Technical Memorandum

To: Linda Loomis, Administrator
Lower Minnesota River Watershed District

From: Katy Thompson, PE, CFM
Della Schall Young, CPESC, PMP

Re: East Chaska Creek Restoration—Final Walk-Through

Photo Location #5: Bank erosion at cross vane.

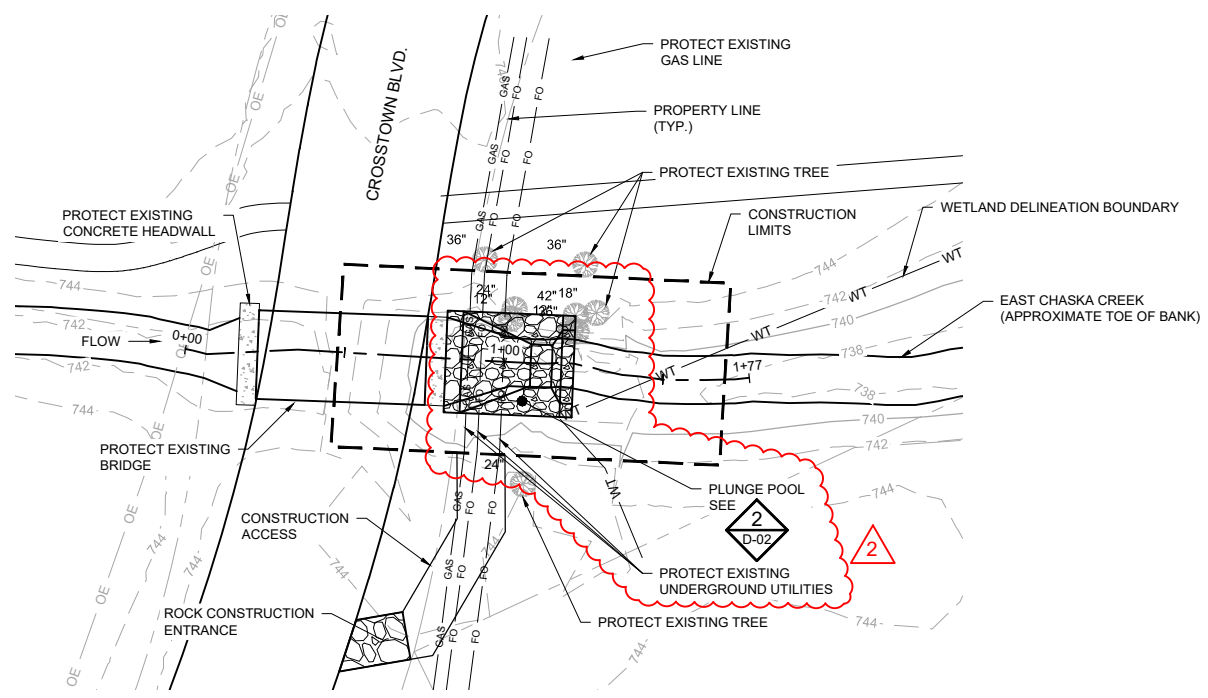
Several of the in-channel rock structures appeared to have caused bank erosion as a result of improper elevations of the header rocks and/or footer logs. These locations were noted by Barr and will be reviewed by the design engineer to determine what actions need to be taken (Attachment 1, Photos 2, 4, and 5).

- *These locations have since been adjusted by Blackstone (Attachment 1, Areas 4 and 5 photos).*
- Area 6: The plunge pool and cross-vane at Crosstown Boulevard conflict with the existing high-pressure gas main and fiber-optic line.

1 PLAN: STREAM RESTORATION (AREA 1)
 SCALE IN FEET: 0, 30, 60

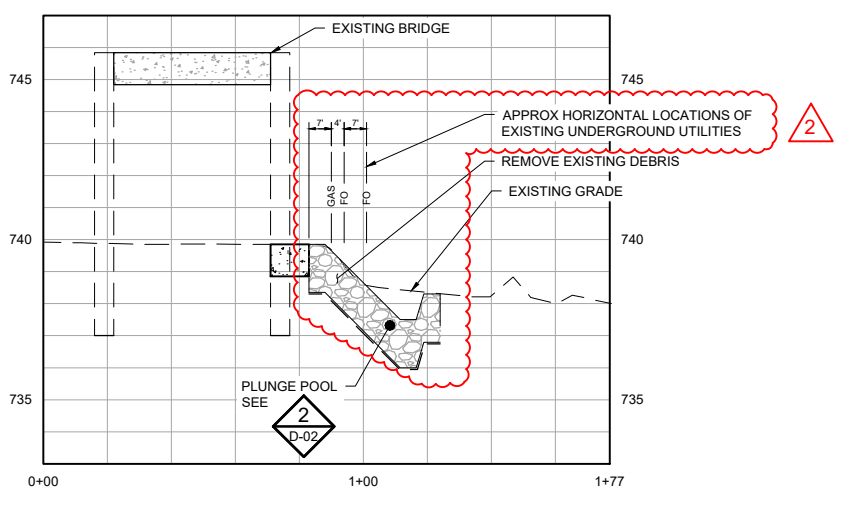
At Crosstown Boulevard, the previous utility locate flag showing the location of the high-pressure gas main downstream from the bridge was still present (Attachment 1, Photo 6). Given the location of the main directly underneath the proposed plunge pool, it was agreed that the plunge pool would be shifted downstream, past the gas main, so that no excavation would occur immediately on top of the main. Sand, filter fabric, and salvaged riprap would be placed on top of the gas main location to extend the bridge apron elevation beyond the gas main, at which point the plunge pool and final boulder weir could be constructed.

Following the site walk, Blackstone called in a new utility location survey and returned to the site on Friday May 7, 2021, to complete the majority of the finish grading, confirmed by the City of Chaska. The utility locate showed the presence of a fiber-optic line approximately five to ten feet downstream from the gas main. The City discussed adjusting the design further by shifting the plunge pool another ten feet, beyond the fiber-optic line. This alternative would increase the amount of riprap needed, but the additional amount needed will have to be determined based on the proposed solution.

At Crosstown Boulevard, the utility location surveys showed the location of a high-pressure gas main and fiber-optic line downstream from the bridge. Because of the utilities, Barr adjusted the proposed design to extend the riprap protection at the bridge apron downstream past the fiber-optic line, then to construct the plunge pool so no excavation would occur immediately on top of the gas main or fiber-optic line. The final cross-vane weir was eliminated from the proposed design after Barr reviewed the channel hydraulics with the modifications and determined this additional grade control structure was not necessary. Barr has also confirmed that although the design has been modified from the originally permitted conditions, the changes are minor and do not affect the original permit terms.

Young Environmental met with Barr on May 12, 2021 to discuss the proposed field fit and whether altering the design would present any issues with the permits. Barr has developed a solution that continues to meet the permit obligations while also protecting the existing utilities (Attachment 2). Further coordination is expected to continue this week, and staff will be prepared to provide an update to the managers as needed.

Final Walk Through—Photo Location 7

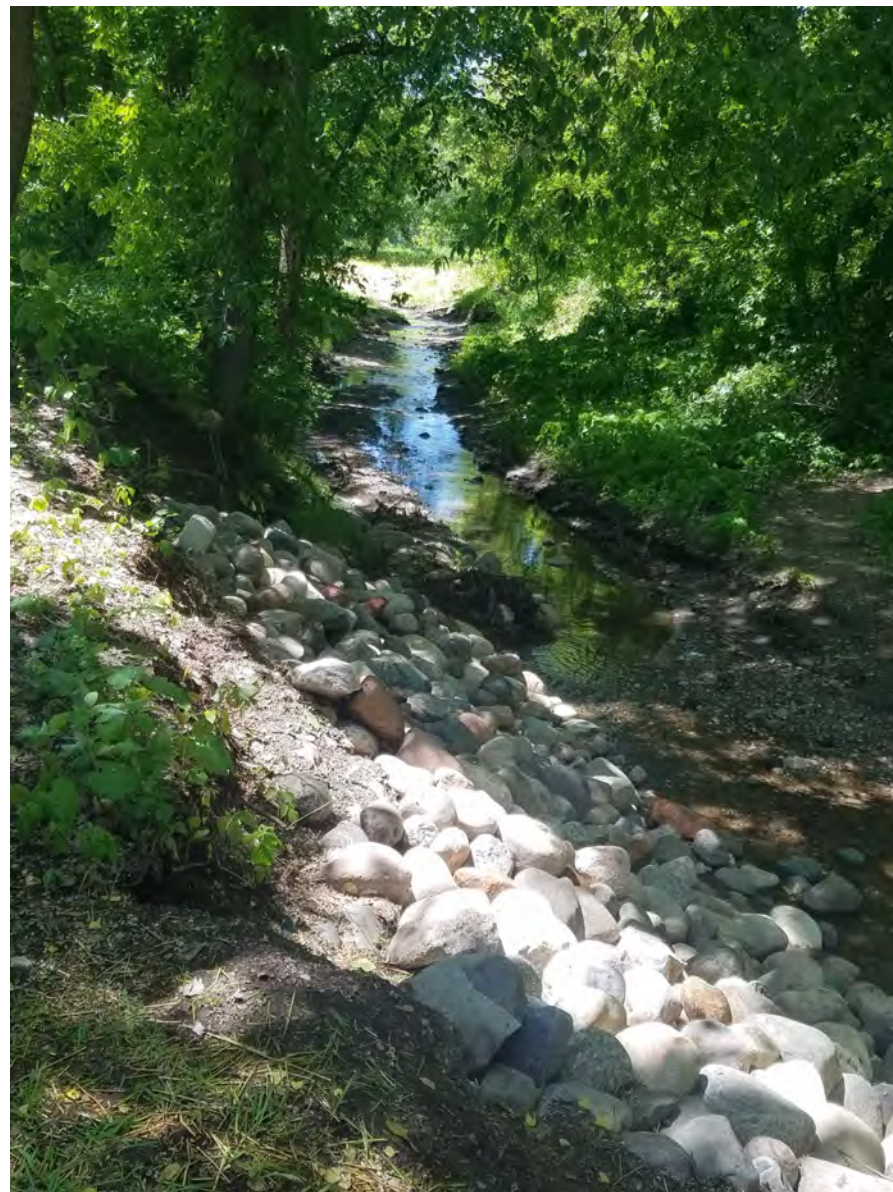
May 6, 2021—Hanging pipe outfalls outside the project limits.

May 28, 2021—Additional riprap placed.
